**WATER SUPPLY IMPROVEMENT PROJECT
FINAL ENVIRONMENTAL IMPACT REPORT**

Letter 24

Subj: Comments on the Indian Wells Valley Water District Water Supply Improvement Project Draft Environmental Impact Report dated October 25, 2011.

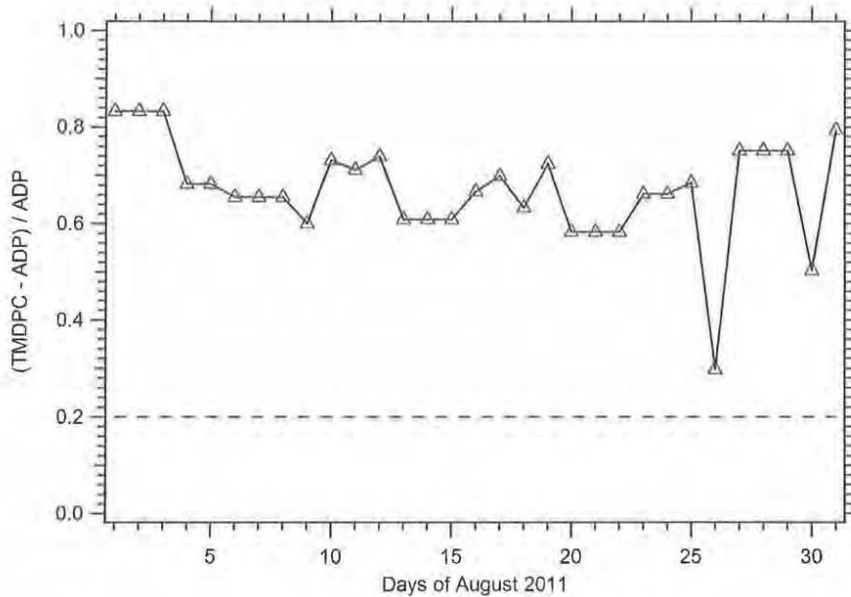
The peak demand day in 2011 was Aug 26 with a pumping total of 12.87 Mgal. This value was obtained by adding the posted daily production for all WD wells on that day (ref 13). Well 18 was not completely down that day but failed on the 27'th. Well 13 was not pumped on the 26'th at all. The total WD well capacity by adding the nominal outputs of the 10 existing functional wells is about 11,600 gal/min. (ref 13). This is 16.7 Mgal/day. **The WD has a "redundancy" right now of 29.8 % above their 2011 peak day. Considering the current production (2011) capability and looking back at actual peak demand going back as far as 2005, the WD has a redundancy not less than 23%. for all those years.**

Several things are very obvious in examining this chart. **The redundancy on most days during the month was above 60% including days on either side of the maximum demand day.** The maximum demand was sustained for only one day. The additional water consumed above adjacent days was about 3 Mgal. This additional water could easily be taken from the 17 Mgal of storage in the WD system. (ref 12) . The question is, who is the WD trying to fool here? If you take the 20% stated “need” as a genuine statement then the WD is confused since they already have a comfortable margin. **It does occur to this writer that the WD may be confounded by the complexity of their antiquated system. I will offer a suggestion in the Alternatives section to bring the WS system up to a modern automated status, thus alleviating any appearance of a need for more capacity.**

Response to Comment 24-9: This comment states that the Proposed Project is not needed because no high demand day failures to provide water over the past four years have occurred. Master Response 7 provides information on this issue.
